PCN# 20250806001.2

**Qualification of additional Fab site (DFAB) and additional
Assembly/Test site (FMX) options for select JI devices
Change Notification / Sample Request**

PCN Number:	20250806001.2	PCN Date:	August 06, 2025
Title:	Qualification of additional Fab site (DFAB) and additional Assembly/Test site (FMX) options for select JI devices		
Customer Contact:	Change Management team	Dept:	Quality Services
Proposed 1st Ship Date:	February 02, 2026	Sample requests accepted until:	October 05, 2025*
*Sample requests received after October 05, 2025 will not be supported.			
Change Type:			
<input checked="" type="checkbox"/> Assembly Site	<input type="checkbox"/> Design	<input type="checkbox"/> Wafer Bump Material	
<input type="checkbox"/> Assembly Process	<input type="checkbox"/> Data Sheet	<input type="checkbox"/> Wafer Bump Process	
<input checked="" type="checkbox"/> Assembly Materials	<input type="checkbox"/> Part number change	<input checked="" type="checkbox"/> Wafer Fab Site	
<input type="checkbox"/> Mechanical Specification	<input checked="" type="checkbox"/> Test Site	<input checked="" type="checkbox"/> Wafer Fab Materials

Sample product shipping label (not actual product label)

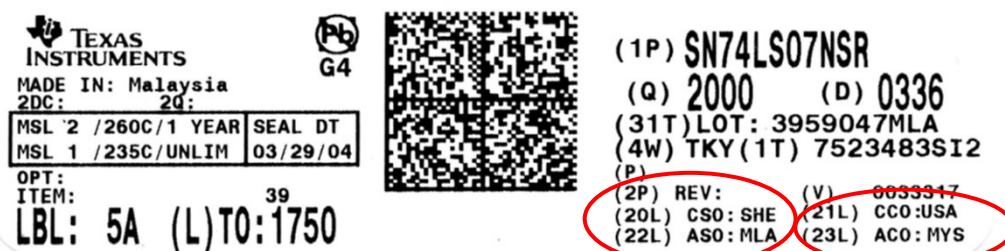
Changes to product identification resulting from this PCN:

Chip Site	Chip Site Origin Code (20L)	Chip Site Country Code (21L)	Chip Site City
SH-BIP-1	SHE	USA	Sherman
DL-LIN	DLN	USA	Dallas

Assembly Site	Assembly Site Origin (22L)	Assembly Country Code (23L)	Assembly City
TAI	TAI	TWN	Chung Ho, New Taipei City
FMX	MEX	MEX	Aguascalientes
